Response to request for further information

To:	Shire of Collie	From:	Planning Solutions
Attention:	David Quelch	Job No:	8660
DA Ref:	P052/25	Date:	17 July 2026
Subject:	Lots 4 (148), 750 (140), 751 (138) and 3 (102-104) Atkinson Street North, Collie Proposed motel development (extension of existing hotel)

1. Planning Solutions act on behalf of Cannaponics Pty Ltd in providing the following response to the Shire's Clause 65A request for further information, received 13 October 2025.

View from Forrest Street looking north towards Lot 750

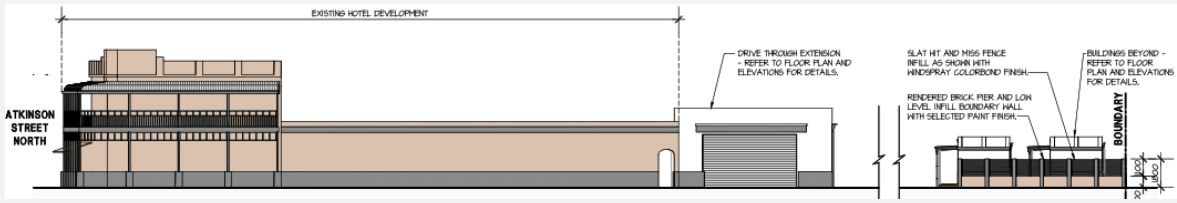
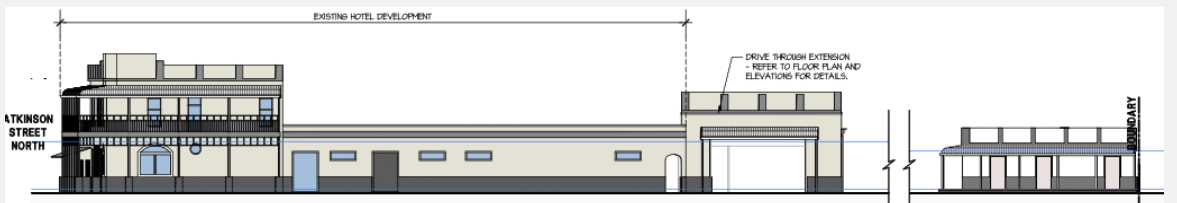
State planning policy 7.0 – Design of the Built Environment – design principles 1 (Context and character); 2 (Built form and scale); and 3 (Aesthetics). • The prefabricated transportable structures present as a rigid series of rectangular blocks which is not a pattern of development that is consistent with the character and amenity of the Collie town centre. • The structures rely on attached awnings and modest landscaping in an attempt to improve the visual appearance but neglects any good design elements such as graduation, articulation and varied roof profile to enhance the streetscape and built environment.	The site layout and elevations have been updated to present as permanent buildings consistent with the architectural style of the existing hotel. Refer updated perspectives enclosed, with a comparison to the lodged perspectives provided below.
Lodged perspective (30 June 2025)	Revised perspectives (17 July 2026)

Summary of issue / requirement	Applicant response
View from Forrest Street looking north towards Bottleshop on Lot 750	
View from Atkinson Street North looking east towards Lot 3	
View from Johnston Street looking south towards Lot 3

Lodged Johnston Street elevations (30 June 2025)

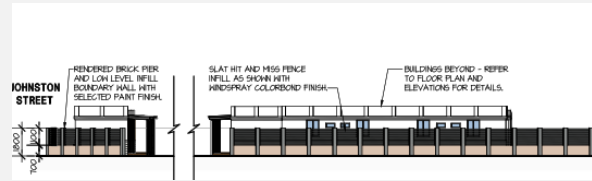
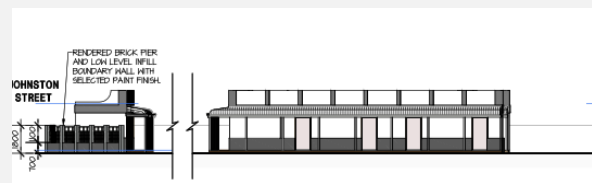
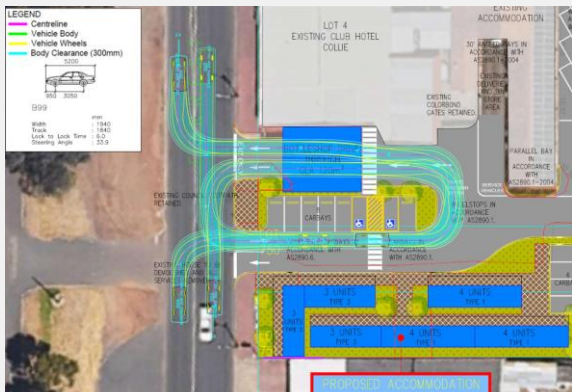
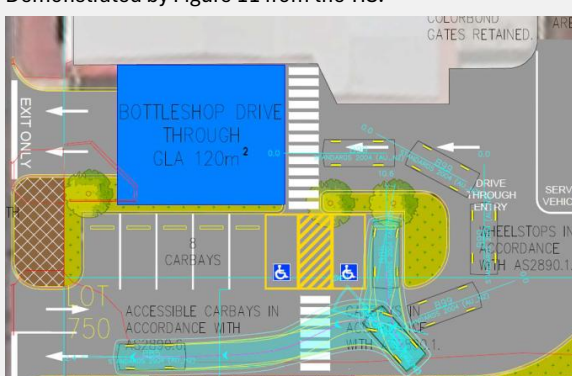
(x) The structures do not contribute to the heritage value of the existing Club Hotel	The development has been redesigned to be more sympathetic to the Club Hotel by— • Using the same colour scheme across the whole site. • Installing bullnose verandahs on the accommodation buildings to tie in with the hotel verandah. • An articulated parapet treatment that reflects the parapet of the hotel; • Aligning the setback of the Lot 750 accommodation buildings with the setback of the drive-through bottle shop. • Removing the masonry walls along the Forrest Street and Atkinson Street North street boundaries. • Replacing the infill panels of the masonry wall along Johnston Street with a design that reflects the balustrade panels of the hotel. This results in the overall the overall site presenting as a cohesive and integrated development.

Amended Johnston Street elevations (17 July 2026)

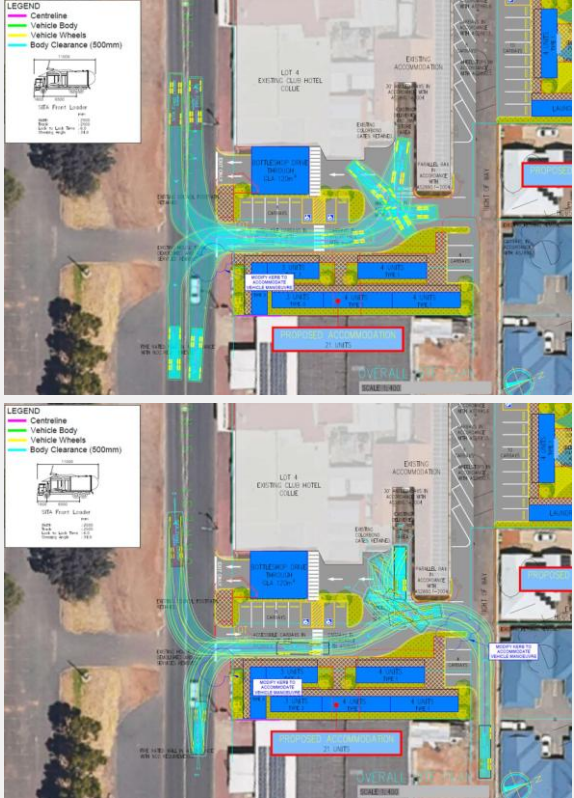
Summary of issue / requirement	Applicant response
Lodged Atkinson Street North elevations (30 June 2025) 	
Lodged Atkinson Street North elevations (17 July 2026) 	
Traffic matters	
Provide a Traffic Impact Assessment.	A Traffic Impact Statement prepared by PTG has been enclosed.
Vehicle manoeuvrability from the Forrest Street Entrance into the bottle shop drive through does not meet the B99 (90th percentile) turn radius prescribed under figures B3 and B4 of AS/NZS 2890.1-2004. Provide a swept path diagram in accordance with standard requirements demonstrating how vehicles can affectively turn into the drive through bottle shop.	Updated development plans enclosed with access, parking and vehicle circulation layout on Lots 4 & 750. Figure 10 of the TIS demonstrates that the B99 design vehicle can adequately turn into the drive-through bottle shop: 
The queuing area for the bottle shop is only 11.5m long. Confirm how vehicles reversing from the adjacent 90 degree parking bays for the residential SOU's will not be adversely obstructed by queueing of more than 2 vehicles.	Demonstrated by Figure 11 from the TIS.

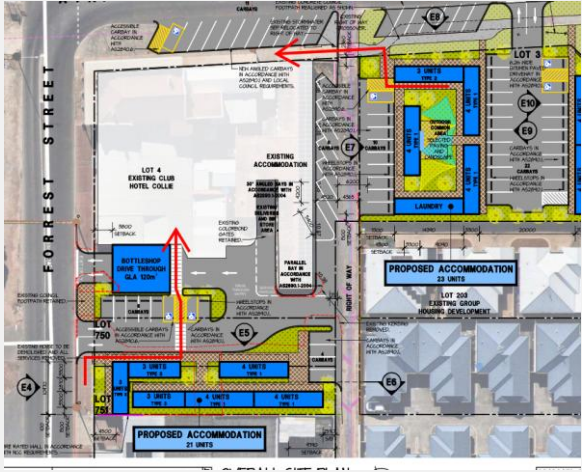
All pedestrian desire lines are aligned with the appropriate pedestrian facilities and destinations within the site and road reserve.	Plans modified to show an additional pedestrian connection from Atkinson Street North; and marked zebra crossings to the bottle shop entrance via the shared space next to relocated disabled parking.

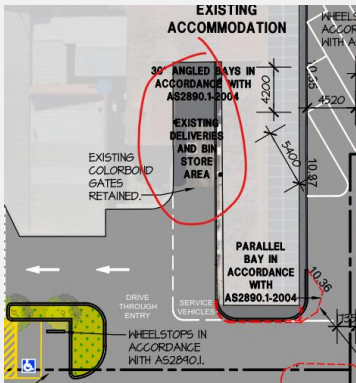
Location of proposed bin area for residences.	Refer Waste Management Plan (WMP) enclosed. All bins will be stored within the existing waste storage area between the hotel and the existing accommodation units.
Proposed bin types (i.e. standard 240L bins or greater?)	2 x 1.5m³ refuse 2 x 1.5m³ recycling 1 x 660L containers for change
The functionality: Design details such as how waste is transported to the bin store, extract bin store location, size and layout and stormwater ingress prevention. The bin store must have the minimum sizing and facilities set-out in the Shire of Collie's Health Local Laws.	Details provided within WMP. Final design details to be addressed with a suitably worded condition of approval.
